Service Bulletin

Subject: Bulletin No: 09-021/09

WATER ACCUMULATION IN FOOTWELL / PLUGGED SOFT TOP DRAINS

Last Issued: 07/17/2009

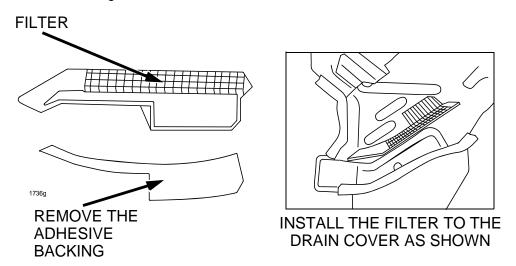
3. Peel the adhesive backing sheet from the filter and affix it to the bottom of the drain cover.

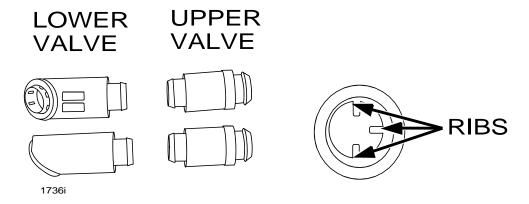
2. Replace the upper and lower valves with modified ones.

NOTE: The modified valves can be identified by the ribs inside the valve.

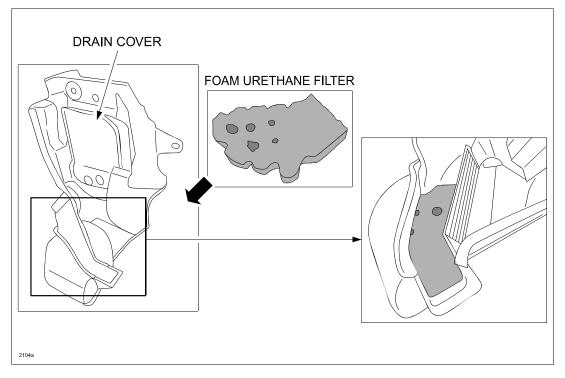
6. Insert a foam urethane filter in the drain cover.
